A G E N D A
FARRAGUT MUNICIPAL PLANNING COMMISSION

March 20, 2014
7:00 p.m. Farragut Town Hall

SUBJECT: Discussion and public hearing on a concept plan revision for the Bridgemore Subdivision, Tax Map 152, Parcel 25.01, 23.69 Acres, 41 Lots, Zoned R-1/OSR (Placemaker Development, Applicant)

SUBJECT: Discussion and public hearing on a concept plan revision for the Cottages at Pryse Farm, 30.81 Acres, 55 Lots, Zoned R-1/OSMR (Wilcox Development, Applicant)

ROAD PROFILES AND DETAILS
BRIDGEMORE UNIT 2
FARRAGUT, TENNESSEE

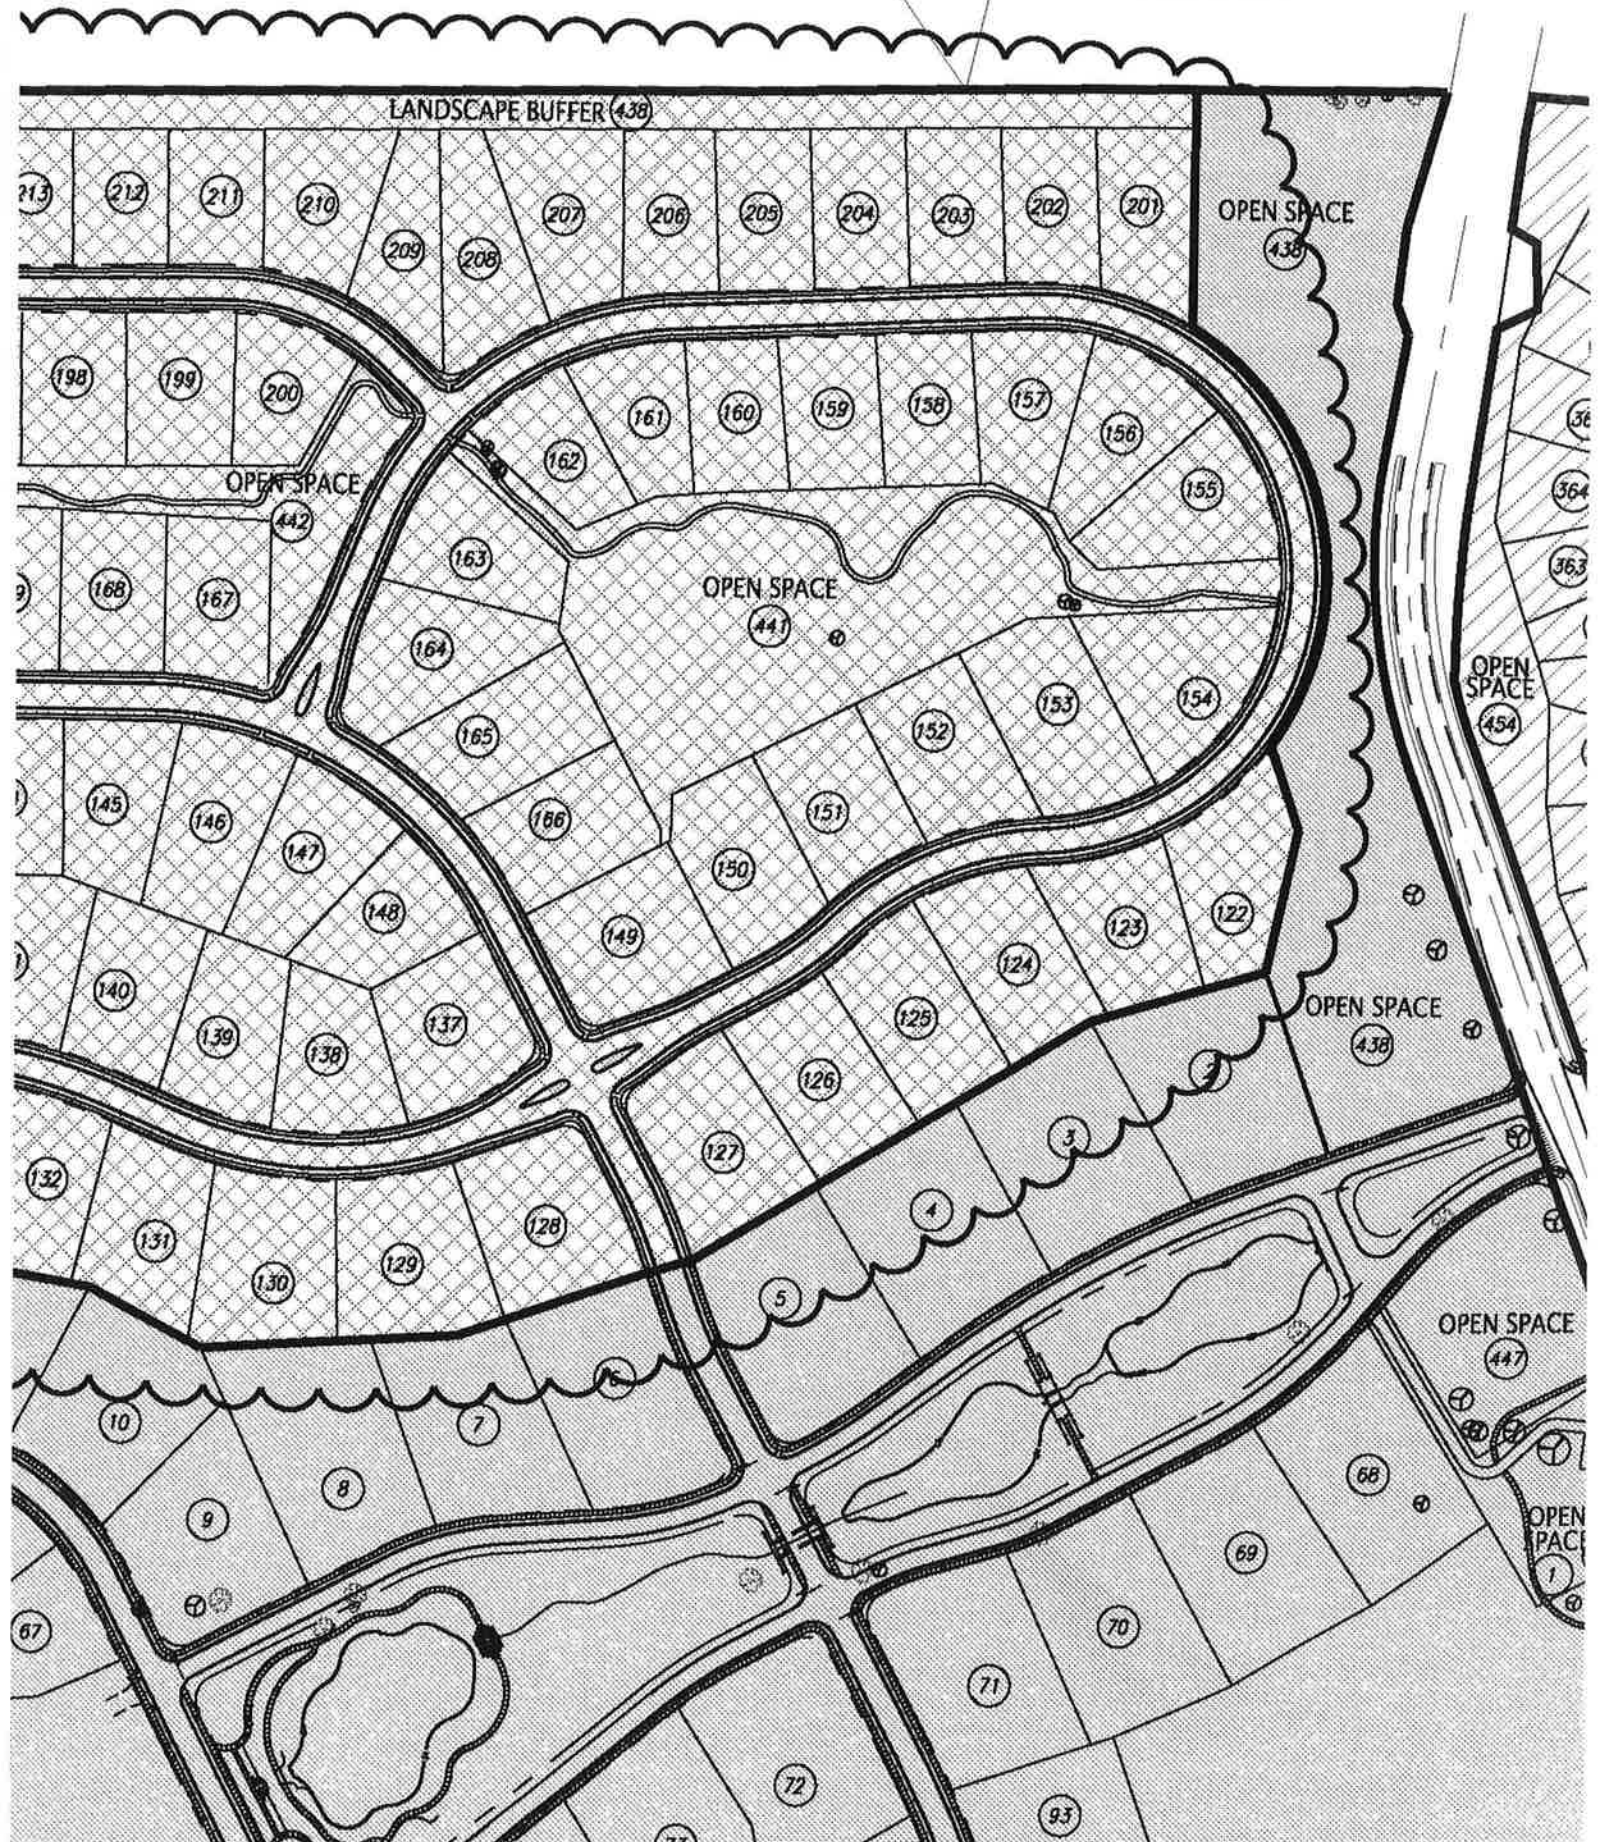
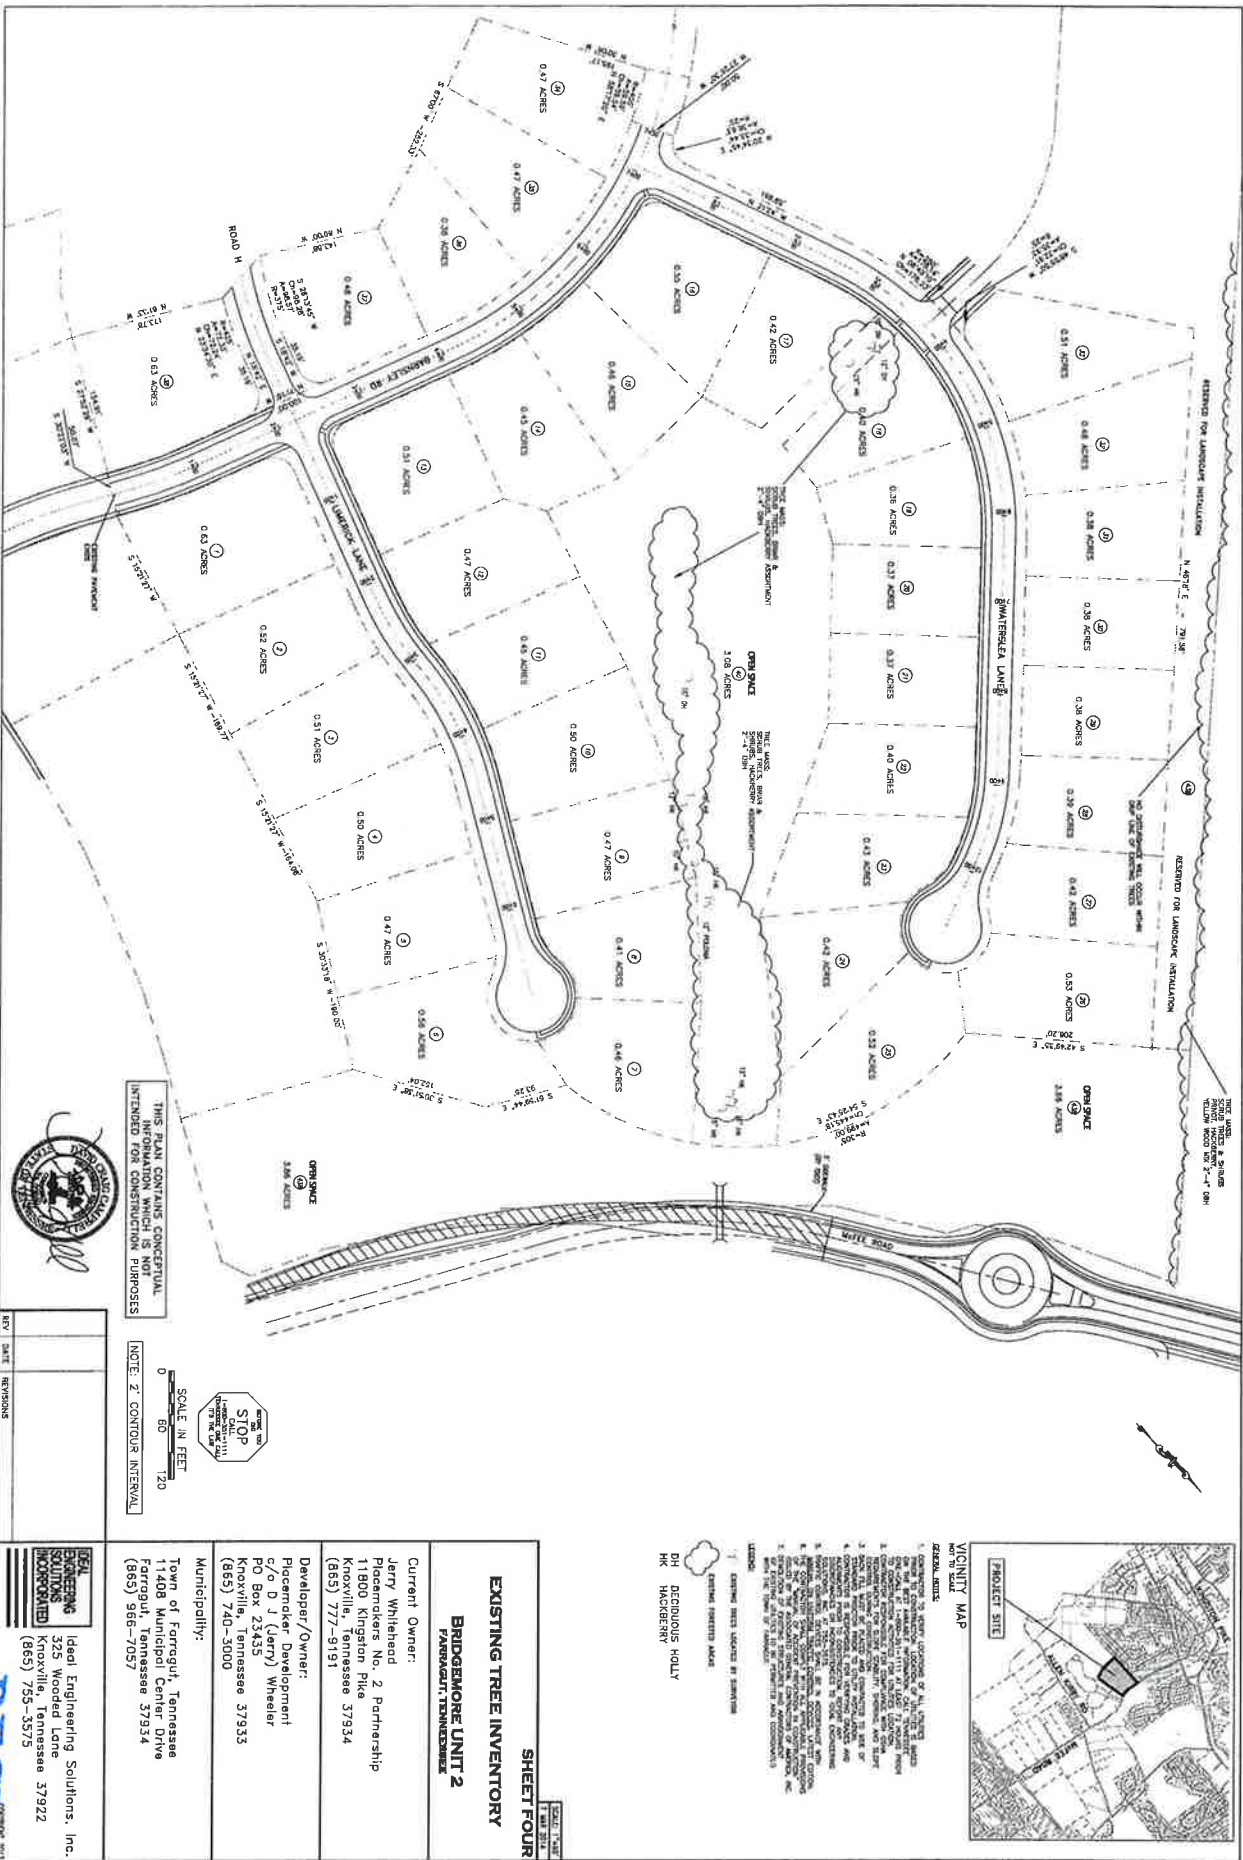
- 1) Roads "F" and "G" are proposed to become cul-de-sacs and have been assigned by MPC the names Waterslea Lane and Limerick Lane;
- 2) Other than a small section along Barnsley Road, sidewalks are proposed to be constructed on one side rather than both sides of roadways;
- 3) The 25 foot wide open space area that abuts the Fort West Subdivision and that has been designated as a landscape buffer (meaning it is to be planted in accordance with the 25 foot

wide buffer strip plant material specifications) is requested to remain as open space but not a landscape buffer; and

- 4) Though not on the current approved concept plan, a walking trail is shown on the preliminary plat that was approved for this portion of Bridgemore on March 2, 2006. The applicant is requesting as part of the concept plan to not construct this walking trail.

- 1) The staff is supportive of the proposed modifications to Roads "F" and "G";
- 2) The planning commission has the authority (and responsibility) to establish the appropriate pedestrian facilities associated with a development where such facilities are required. There is no requirement that sidewalks be constructed on both sides of a local street. The existing portion of the Bridgemore Subdivision does include sidewalks on both sides of the street. This is what was presented to the planning commission based on the desires of the developer at that time.

Provided this can be properly transitioned and is part of a larger integrated pedestrian system within this subdivision, the staff is supportive of the request to construct sidewalks on one side of the local streets within the remainder of the larger lot portions of the Bridgemore Subdivision. Though this could be re-evaluated in the future, sidewalks should still be shown on both sides of the street in the smaller lot portions of Bridgemore due to more potential for pedestrian/vehicular conflict. Since, in most cases, the Town ultimately is responsible for the maintenance of sidewalks, installing them on one side of local streets that do not have high traffic volumes is preferable to installing them on both sides of such streets;

- 3) When Bridgemore was originally approved, a 25 foot wide landscape buffer was platted where it abuts the Fort West Subdivision. Buffer strips are not mandatory in the R-1/OSR but may be required by the planning commission when it is determined that a buffer strip is necessary to promote compatibility with an abutting land use. Though this is something that needs to be evaluated and discussed with input from the Fort West Subdivision, a planted buffer strip would make sense where the type of development in Bridgemore would be visually distinct (e.g. much smaller lots, more compact building placement, etc.,) from Fort West. A planted buffer along the western portion of Bridgemore (where smaller lots are proposed on the concept plan) would seem to be more necessary than in the larger lot portion of the development to the east;

- 4) As noted above, the existing concept plan for Bridgemore does not show a walking trail through the open space lot that is shown as Lot 40 on the concept plan amendment proposed at this time. However, when the more detailed preliminary plat was approved on March 2, 2006, a walking trail was shown through this open space as part of a larger comprehensive walking trail system. In fact, item #11 in the minutes from this meeting (which are included in the packet) reference this walking trail and note that it is "required in order to meet the minimum open space requirements for this phase."

The applicant is requesting to not construct the walking trail through this area due to drainage/topographic issues. Consistent with the subdivision regulations, the planning commission may consider an alternate comprehensive pedestrian system for the subdivision. One component of an alternate system that the staff would encourage is a pedestrian connection from the sidewalks proposed at the ends of each cul-de-sac to the sidewalk along McFee Road. Such connections would provide loop opportunities and would likely be heavily used especially with the Wentworth/McFee Road walking trail bridge and connector that will be constructed on the east side of the roundabout that is northeast of this portion of the Bridgemore Subdivision.

Related to many of these issues, a major problem with the concept plan as presented (and which has been pointed out to the applicant in previous correspondence) is that it still does not address the entire Bridgemore Subdivision concept. The requested modifications at this time must be integrated with the remaining undeveloped portions of Bridgemore so that there is a seamless transition throughout the development and not a series of “mini-concepts” within the development. One example of what the staff is referring to is that on the revised concept drawing the applicant does not show any walking trails in any of the remaining undeveloped portions of Bridgemore. This would obviously be something that must be corrected.
